ADDENDUM NO: 3

PROJECT: BCSC Columbus East High School – C4 Addition

PROJECT NO: 2025022 DATE: 11/10/2025 BY: Josh Cannaday

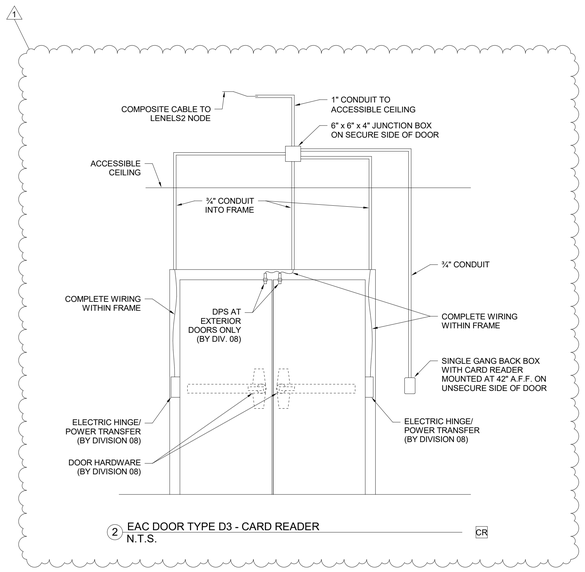
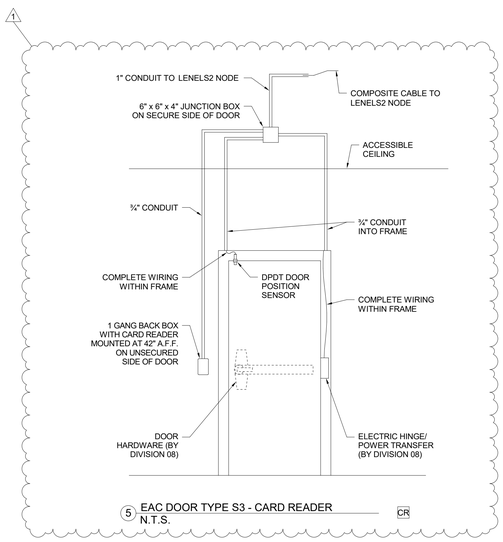
3.48 SHEET T403 – SECURITY DETAILS

C. Added new Detail #2 – EAC DOOR TYPE D3 - CARD READER

D. Added new Detail #5 – EAC DOOR TYPE S3 - CARD READER
